AMENDMENT OF SOLICITATION/MODIFICATION OF CONTRACT			1. CONTRACT ID CODE J	PAGE OF PAGES 1 3
2. AMENDMENT/MODIFICATION NO. 0001	3. EFFECTIVE DATE 09-Sep-2016	4. REQUISITION/PURCHASE REQ. NO.		5. PROJECT NO.(If applicable)

14. DESCRIPTION OF AMENDMENT/MODIFICATION (Organized by UCF section headings, including solicitation/contract subject matter where feasible.) Respond to Pre-Proposal Inquiries				
Except as provided herein, all terms and conditions of the document referenced in Item 9A or 10A, as heretofore changed, remains unchanged and in full force and effect.				
15A. NAME AND TITLE OF SIGNER (Type or print)		16A. NAME AND TITLE OF CONTRACTING OFFICER (Type or print)		
		TEL:	EMAIL:	
15B. CONTRACTOR/OFFEROR _____ (Signature of person authorized to sign)	15C. DATE SIGNED	16B. UNITED STATES OF AMERICA BY _____ (Signature of Contracting Officer)		16C. DATE SIGNED 09-Sep-2016

The following Pre-Proposal Inquiries were received and responses are provided as follows:

ELEVATION

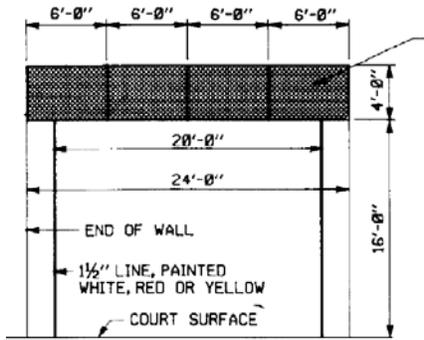
INQUIRY 003:

4.8 OUTDOOR ONE WALL HANDBALL COURT

In description of this image, there is a missing in annotation in the right there is an arrow with any information. (other word what is the Materials over the RC wall)
